## **Washington Center**

Washington Center

Accessibility Review

Transition Plan - (location/priority)

**Photo 1:** Currently the designated accessible parking spaces are reserved for resident parking.

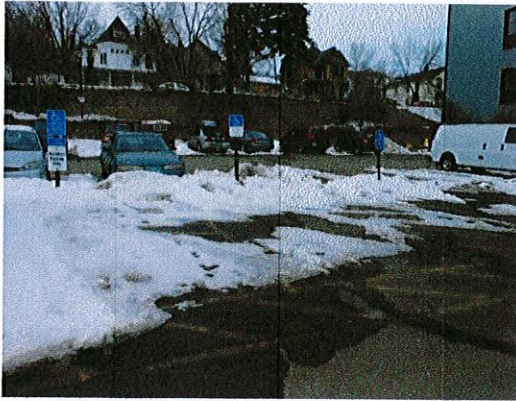
Location JQP # / Item #	Solution / Comments	Qty	Unit Cost	Total Cost	Priority	Estimated Compl. Date	Person Responsible	Actual Compl. Date	Actual Cost
<b>Parking</b>									
05A 16573	Stripe an appropriate number of accessible parking stalls and provide appropriate permanent signage. IBC 1106.1 <i>There are approximately 15 public parking spaces (the remainder are reserved for residents), currently no public spaces have been designated as accessible. Photo 1.</i>	1	\$400	\$400	2				
				<b>Priority # 2 Total</b>	<b>\$400</b>

**Photo 2:** Patch the accessible route to eliminate any changes in elevation greater than 1/2".

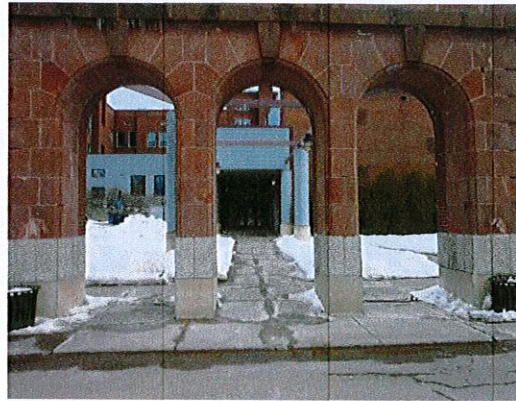
There is not currently accessible parking designated associated with Washington Center (all designated accessible parking is reserved for the residential units). An on-grade route is provided from the parking lot to the main entry, however the surface of the route is deteriorating.

**Photo 5:** There is 1 door into the gym that provides a 32" clear opening, however the door is recessed and does not provide maneuvering clearance.

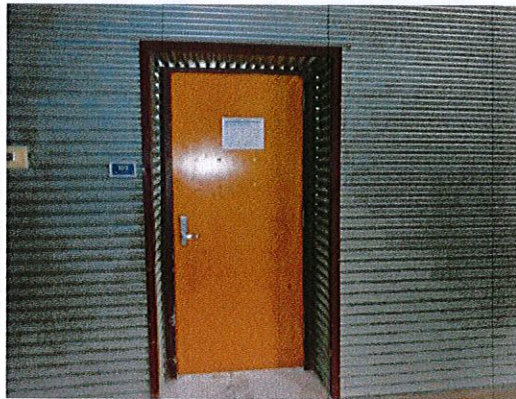
Location	Solution / Comments	Qty	Unit Cost	Total Cost	Priority	Estimated Compl. Date	Person Responsible	Actual Compl. Date	Actual Cost
JQP # / Item #									
<b>Building Wide</b>									
40B	16536	Provide compliant raised and Braille permanent room identification signage. MN 1341 1110.2 <i>Raised and braille signs are provided, currently many of the signs are missing.</i>	15	\$40	\$600	3			
<b>Exterior Route</b>									
07G	16574	Patch lip at the base of the curb cut / ramp so there is no abrupt rise greater than 1/2". ICC / ANSI 303 <i>Photo 2.</i>	1	\$50	\$50	3			
08D	16575	Bevel abrupt rises in the sidewalk. ANSI 303.3 <i>Photo 2.</i>	1	\$500	\$500	3			
				<i>Location Subtotal:</i>					\$550
<b>Gym</b>									
20A1	16572	Modify widths of double doors (1 large/1small) to provide a single leaf with a minimum 32" clear opening. ICC / ANSI 404.2.2 <i>There is 1 entry door that provides a 32" clear opening, it is recessed and does not provide maneuvering clearance. There are 3 sets of double doors- a single leaf of the double door currently provides a 27" clear opening. Photos 4 and 5.</i>	1	\$1,500	\$1,500	3

**Photo 6:** The pool is currently empty and the space is used for storage. If the pool is used in the future; ensure a compliant pool lift is provided.

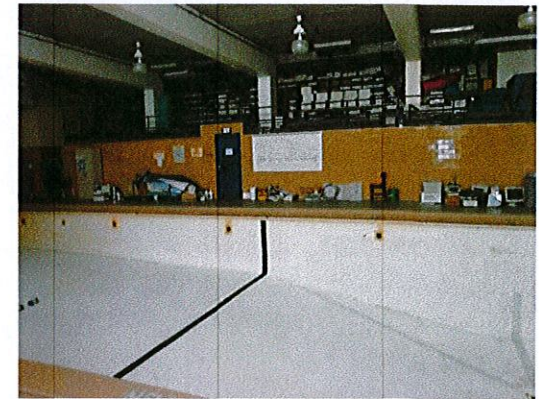
Location JQP # / Item #	Solution / Comments	Qty	Unit Cost	Total Cost	Priority	Estimated Compl. Date	Person Responsible	Actual Compl. Date	Actual Cost
<b>Pool</b>									
66A	16570 Provide a ramp or lift to access the water. IBC 1111.2 <i>All of the water has currently been drained from the pool and the room is used for storage. If it is used as a pool again, provide access into the water. Photo 6.</i>	1	\$5,000	\$5,000	4				
66B	16571 Identify accessible viewing positions on the pool deck. IBC 1108.2 <i>There is not currently an accessible route to the spectator seating area. Currently the pool area is used for storage.</i>	1	\$0	\$0	4				
<b>SW Entry</b>									
20P	16543 Lower the window in the door (or the sidelite) so the bottom is at 43" maximum. ICC / ANSI 404.2.10 <i>Currently at 45".</i>	1	\$250	\$250	4

**Photo 7:** View of toilet room. Lower the sink to children's standards at this location to eliminate the need for the wood platform.

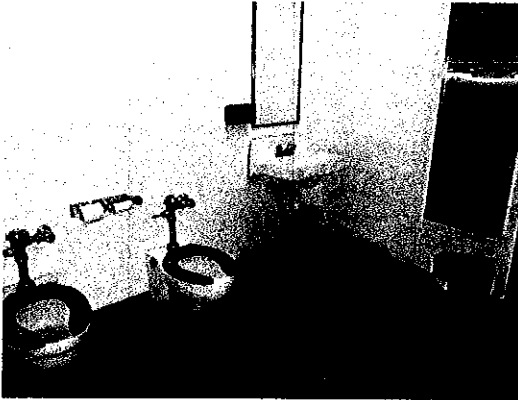
22Z 16555	Provide a coat hook positioned so the highest operable part is no higher than 48". ICC / ANSI 604.11	1	\$50	\$50	3				
23P (MN) 16558	Relocate the lavatory to provide a minimum knee clearance height of 24". Ensure the rim or counter surface is no higher than 31". ANSI 606.2, Exception 3 <i>This location is currently use by ECFE students, a door has been added from the corridor. Lower the sink to children's standards. (There is currently a wood platform below the sink.) Photo 7.</i>	1	\$450	\$450	3				
				<i>Location Subtotal:</i>					\$1,690
				<b>Priority # 3 Total</b>					<b>\$16,510</b>

**Photo 8:** The toilet rooms have been remodeled to provide features of accessibility. In the women's toilet room relocate the toilet paper dispenser and sanitary waste receptacle to below the side grab bar.

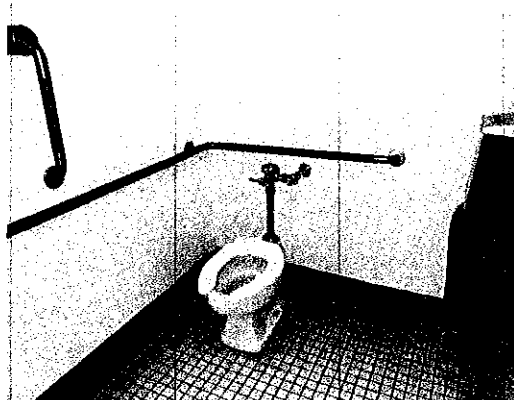
22W2	16569 Relocate the sanitary product receptacle in the accessible stall. The sanitary product receptacle should be located 1 1/2" minimum below the horizontal grab bar and 18" minimum above the floor and 12"- 40" from the rear wall. MN 1341 604.7 <i>Photo 8.</i>	1	\$50	\$50	3				
				<i>Location Subtotal:</i>					\$240
